Critique of Cuadrilla's plans and proposals for drilling near Balcombe, West Sussex

David Smythe

Emeritus Professor of Geophysics, University of Glasgow

This slideshow discusses Cuadrilla's published proposals for re-drilling the Balcombe-1 well. Since it is somewhat technical in places, here is a summary:

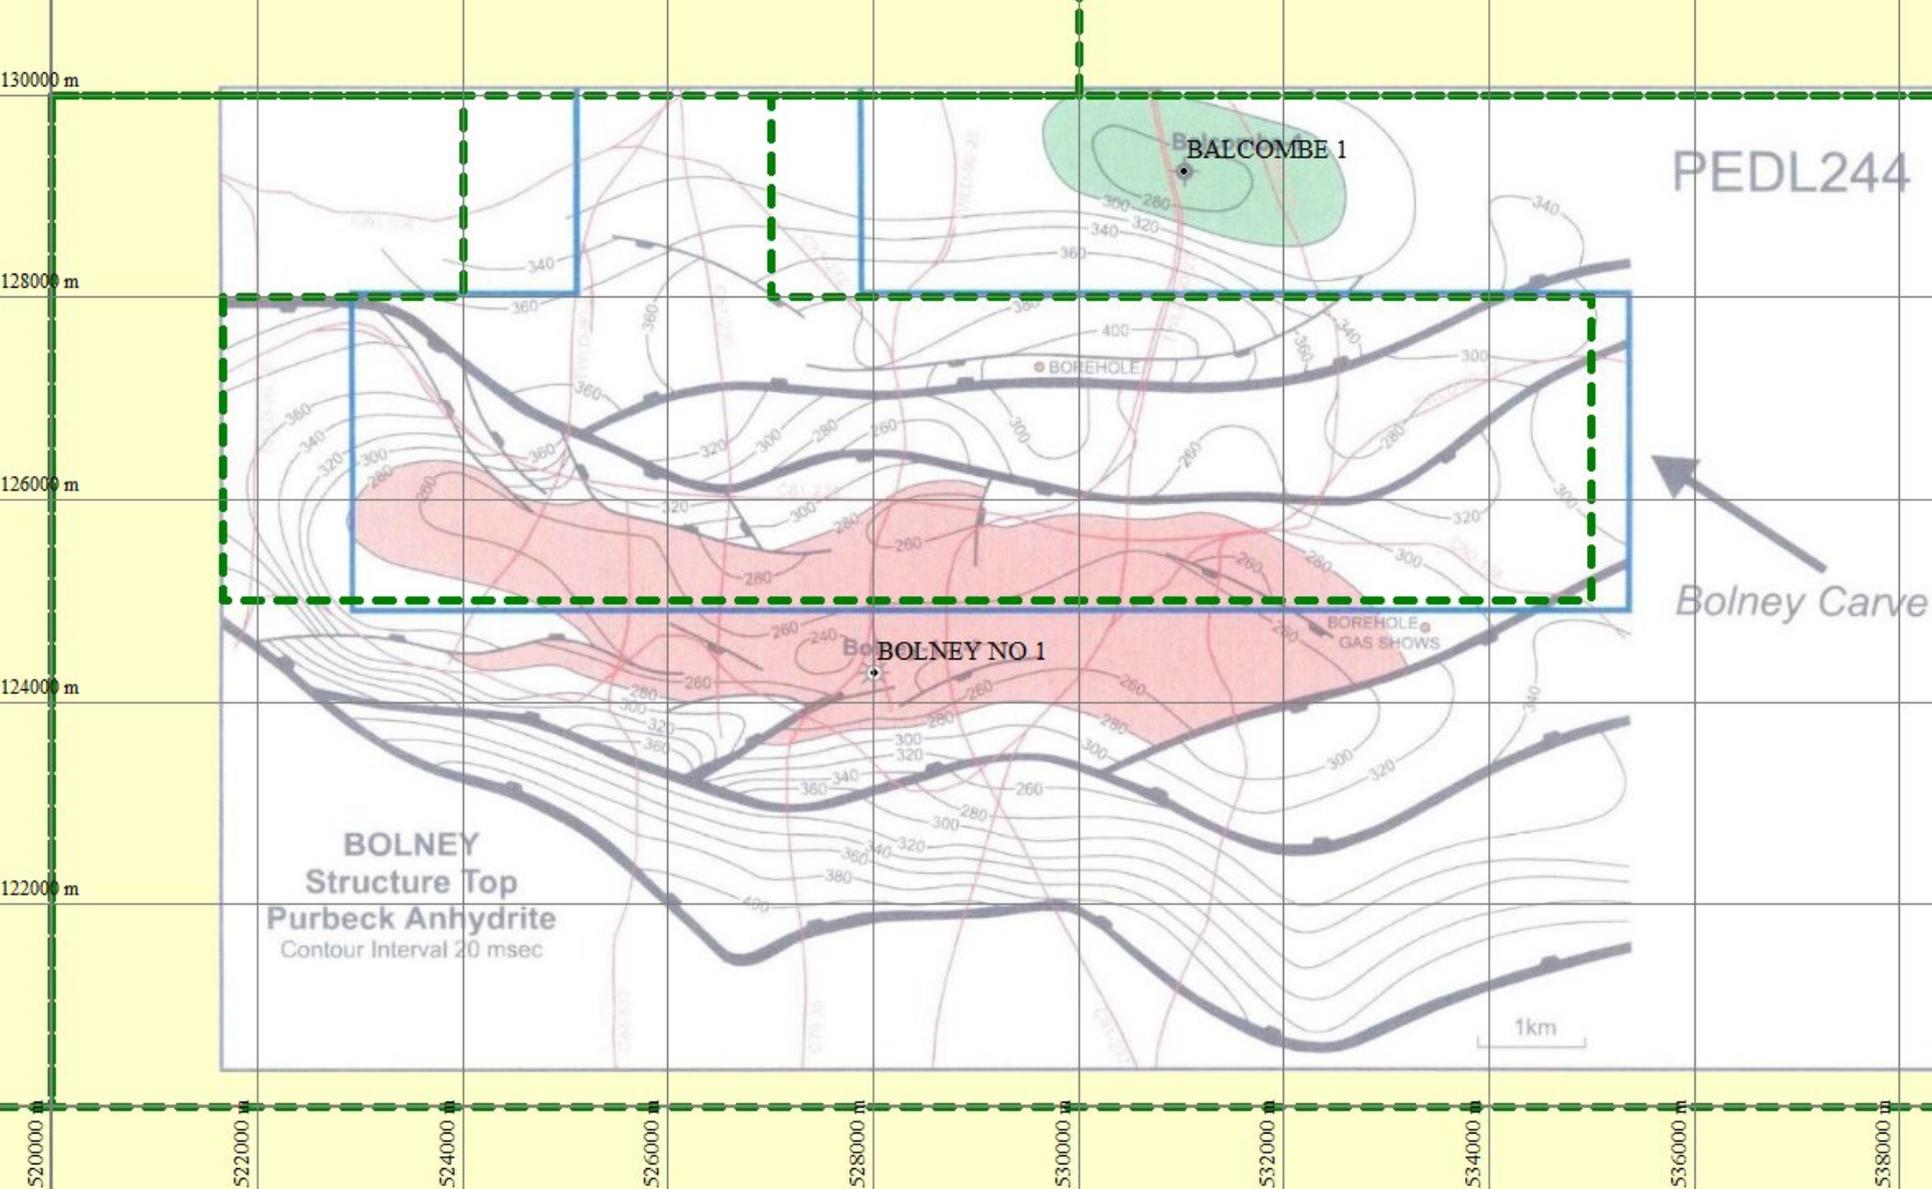
This is Cuadrilla's geological map for the top of the Purbeck Anhydrite, a layer about 240 m above the micrite target. The two old exploration wells, Balcombe-1 and Bolney-1, serve to calibrate the depths. Major faults generally running east-west are shown by thick black lines with a comb mark on the side which is displaced downwards. Away from the wells the interpretation depends upon old 2D seismic profiles, shown as thin red lines.

The green oval marks an area of 'closure', that is, a gentle dome-shape under which oil or gas could collect, if present. The red area marks a similar closure around the Bolney-1 well.

The blue polygon labelled 'Bolney carve-out' is an area *excluded* from the much larger PEDL244 licence area, but this area is wrongly positioned.

Cuadrilla mapping error

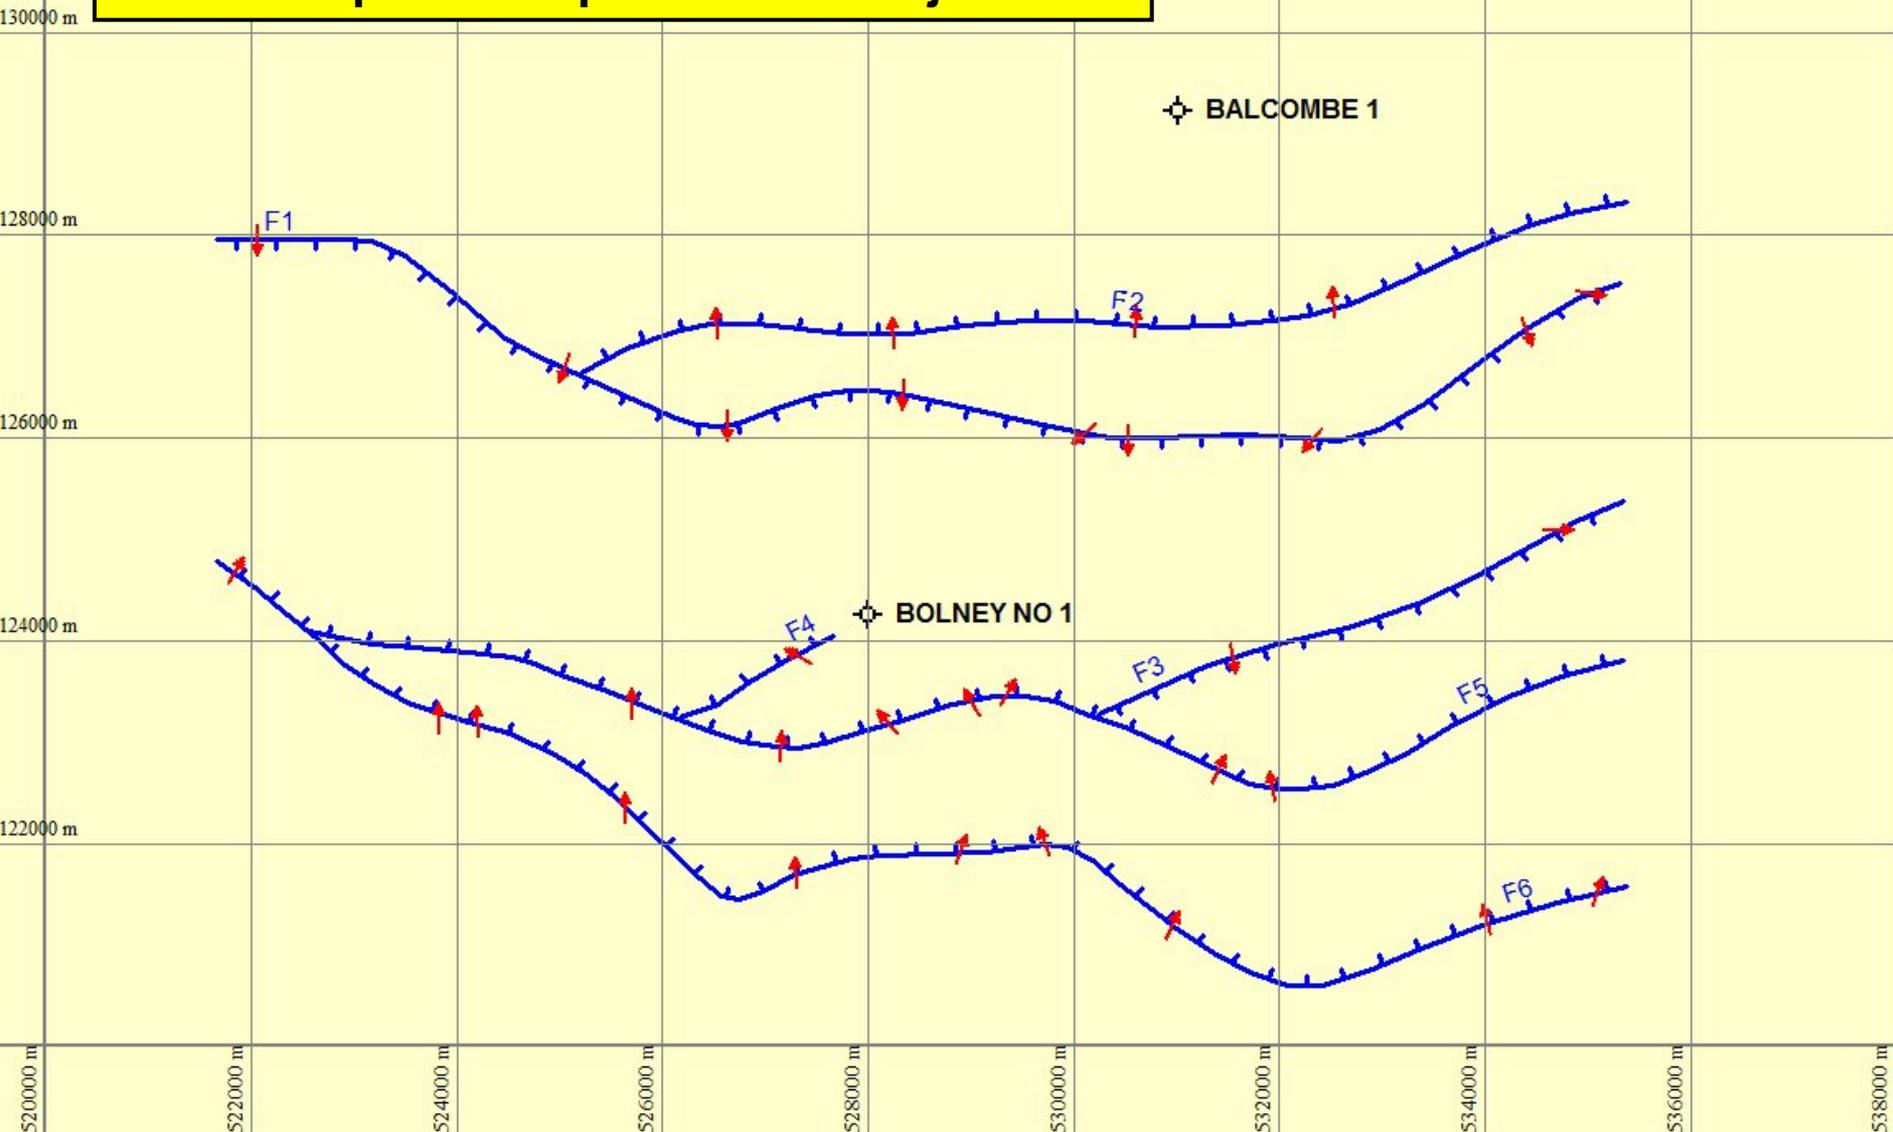
The Cuadrilla licence application map has been merged into a digital mapping program by registering it using the two wells, whose digital position is shown. A further check is that the seismic lines (red) now match the government database (not shown). But note how the DECC licence boundary (green dashes) mismatches that on the Cuadrilla map (blue) by up to 1200 m.

Cuadrilla: poor interpretation of major faults

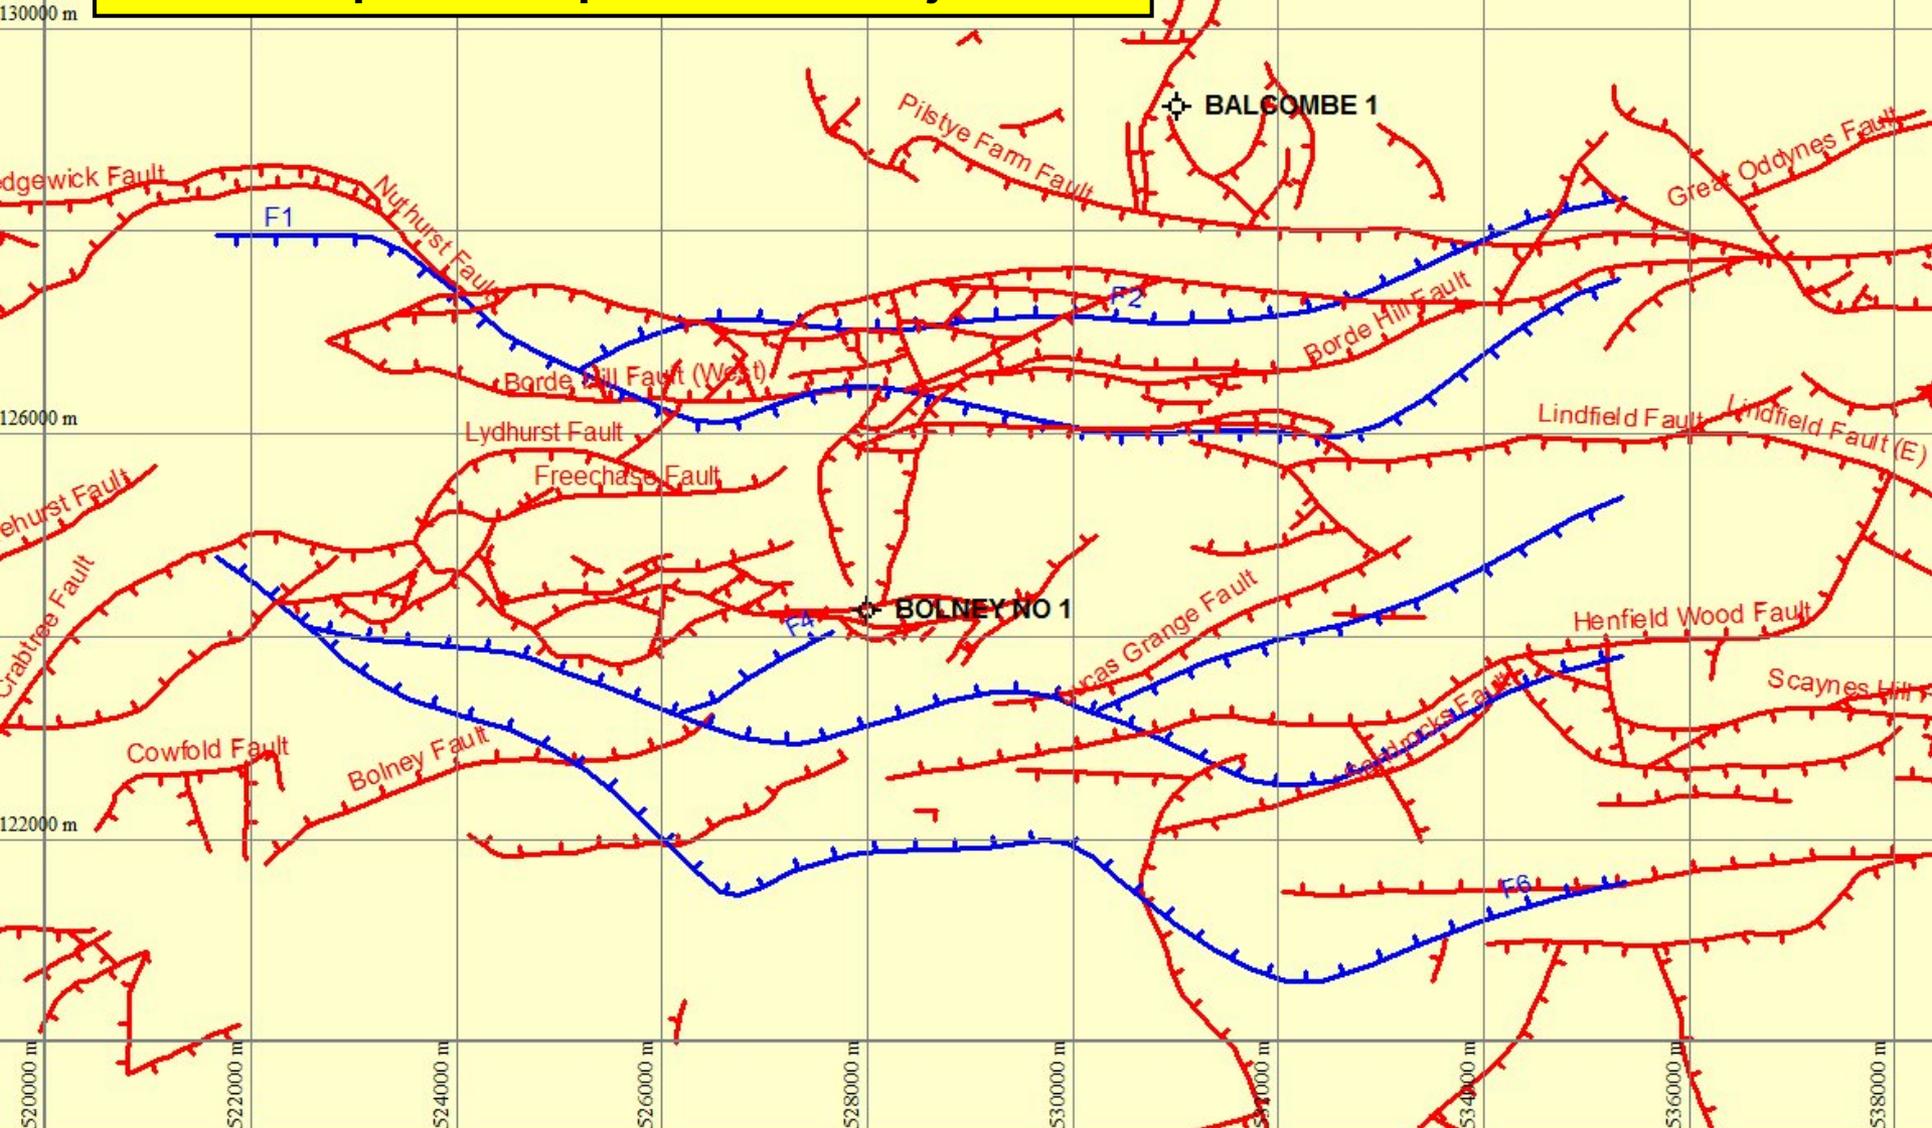
The major faults mapped by Cuadrilla are in blue, with control points from 2D seismic lines shown by red arrows. The direction of arrow is along the seismic line, pointing to the downthrown side of the fault (shown by the comb marks on the faults).

Cuadrilla: poor interpretation of major faults

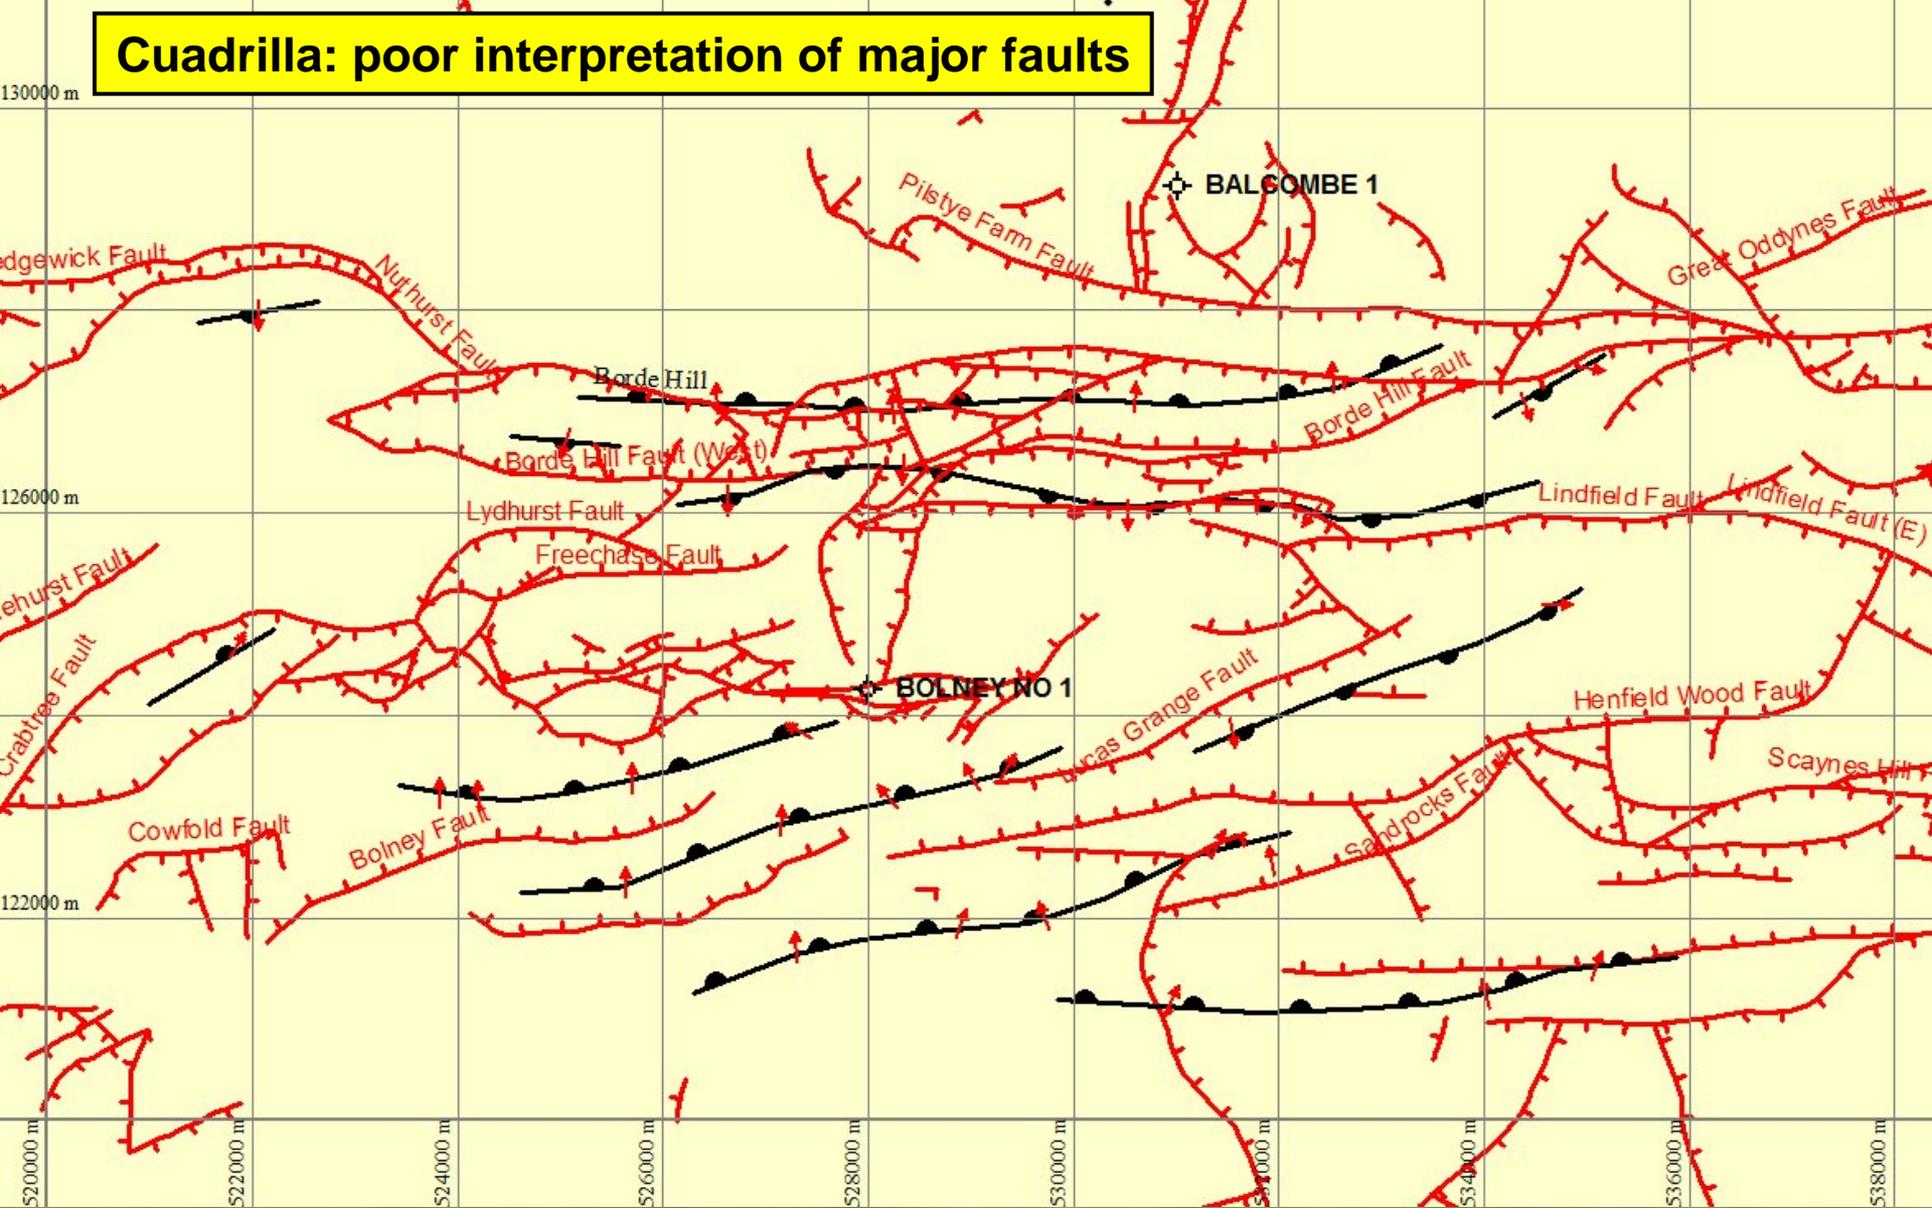
In the southern part of the interpretation the Cuadrilla faults at around 500 m depth have poor correlation of trend compared to the surface faults (red) as mapped by the BGS.

Cuadrilla: poor interpretation of major faults

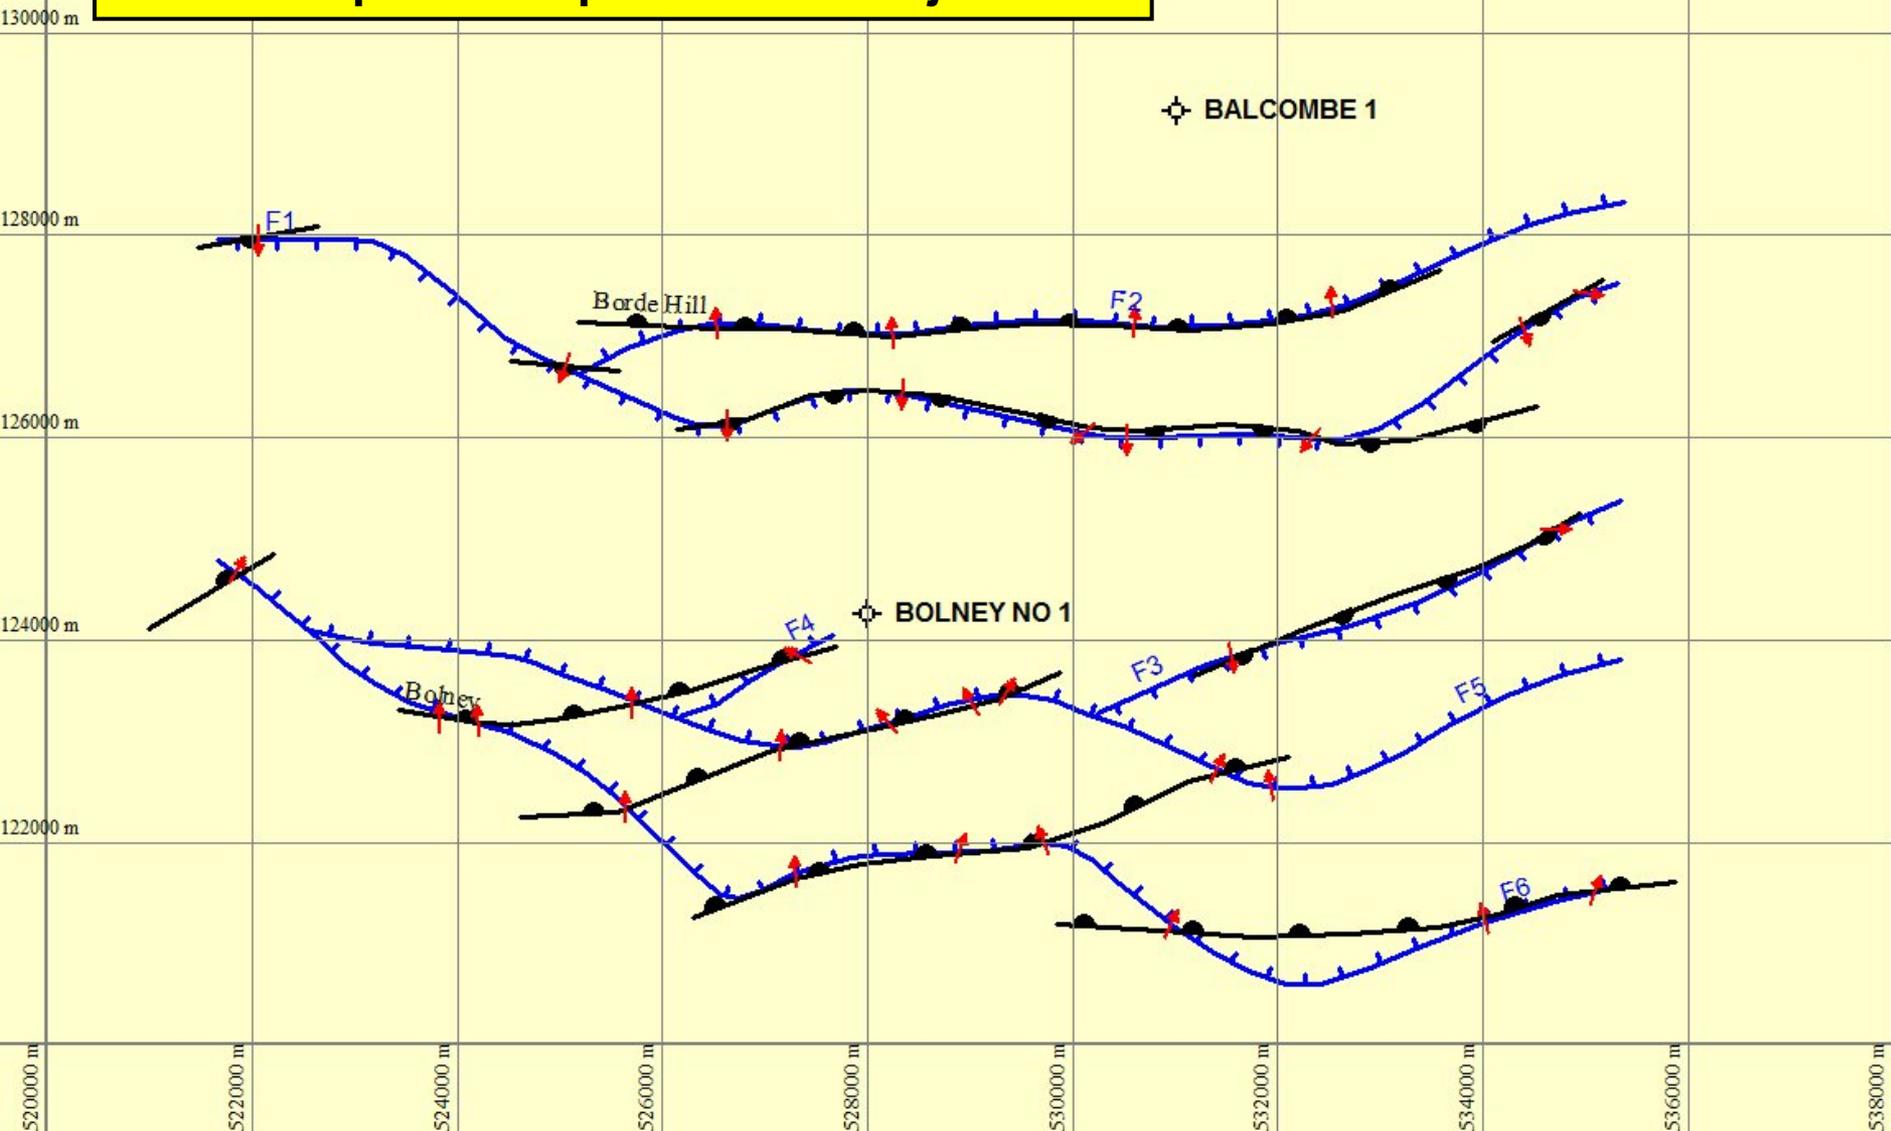
The black lines with half-moons are my re-interpretation of the major faults at depth, honouring the control points (red arrows) and also the general trend of the surface faulting.
